SUBJECT: Report of the Meeting of the Ad Hoc Committee of UL for Commercial Refrigerators and Freezers; Request for Comments on Proposed Requirements for the Sixth Edition of the Standard for Wired Cabinets, UL 65; for the Eighth Edition of the Standard for Commercial Refrigerators and Freezers, UL 471; and for the Ninth Edition of the Standard for Fluorescent-Lamp Ballasts, UL 935; PROPOSED EFFECTIVE DATES

A meeting of the Ad Hoc Committee of UL for Commercial Refrigerators and Freezers was held at UL's Northbrook office on May 22, 1997. The purpose of the meeting was to discuss issues relating to the use of ballasts in wired cabinets and commercial refrigerators and freezers.

PROPOSED REQUIREMENTS AND PROPOSED EFFECTIVE DATE FOR THE NINTH EDITION OF THE STANDARD FOR FLUORESCENT-LAMP BALLASTS, UL 935

PROPOSED REQUIREMENTS FOR THE EIGHTH EDITION OF THE STANDARD FOR COMMERCIAL REFRIGERATORS AND FREEZERS, UL 471

Figure 27A.1
Arcing test set-up

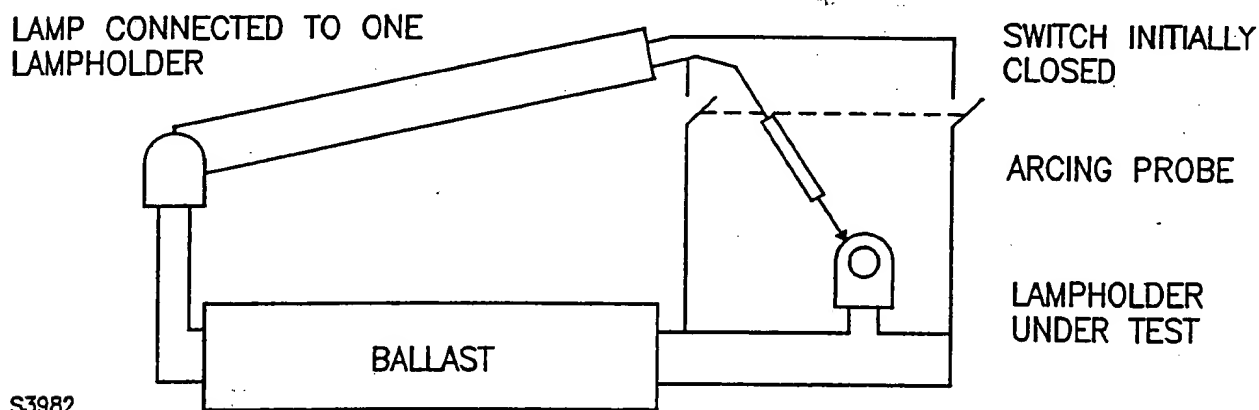
27A.2 The ballast is to be connected as for normal operation except that one lamp is to be disconnected at one end. Additional wiring and a switch are to be added as typically shown in Figure 27A.1. An arcing probe is to be attached at the "free" end of the lamp and the switch, as shown in Figure 27A.1, is to be initially closed. The ballast is to be connected to a source of supply energized at the input voltage and frequency in accordance with 19.7.

27A.3 The lampholder not connected to the lamp is to be wrapped with a single layer of cheesecloth. The arcing probe is to consist of a 1/8 inch (3.2 mm) diameter brass rod sharpened to a point and embedded in an insulating handle.

27A.4 After normal operation is established, the switch shown in Figure 27A.1 is to be opened and an attempt made to create an arcing condition by use of the arcing probe. The arcing probe is to be inserted through the layer of cheesecloth and the attempt to create an arcing condition made by continuing lamp current, and then by drawing back the arcing probe in order to create an arcing condition. The attempt at arcing is to continue for 15 minutes, unless it is obvious in less time what the final result will be.

27A.1 An electronic ballast marked "Type CC" (see 39.5.11) shall be subjected to the test described in 27A.2 – 27A.4 without resulting in a continuous arcing condition that would cause burning or charring of cheesecloth.
